## Product Change Notice (PCN)

PCN Number: PCN-65280402R-01

- VMS-300-x-y (x=12, 15, 24, 36, 48, 0512 or 1224; y=blank, CF or CFS) series
- VMS-300-Dx-y (x=12, 15, 24, 36, 48, 0512 or 1224; y=blank, CF or CFS) series

For U & CF type - Current terminal block-

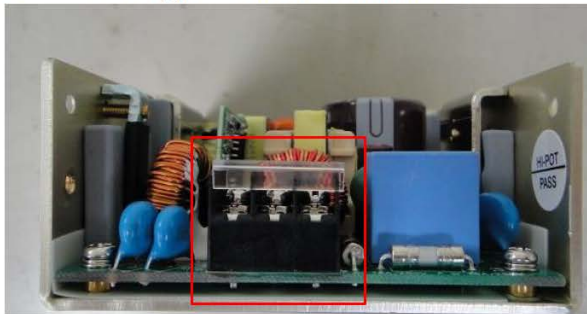
**Description of Change:** IEC 60601-1: 2005+ A1, EN60601-1: 2006+A11+A1+A12 requires input connector to have European approval (TUV, VDE or EN/EC etc.). The new connector, which meets European approval, does not have the plastic cover. See updates highlighted within Red squares in the images below:

New terminal block-

For CFS type - Current terminal block-

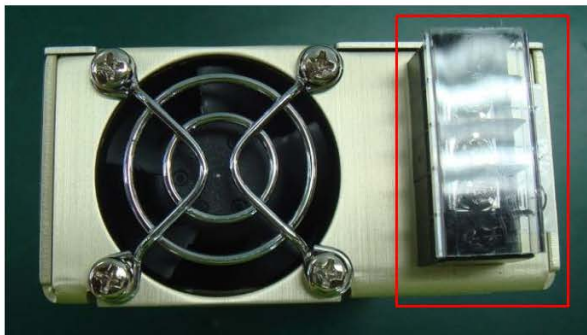
New terminal block-
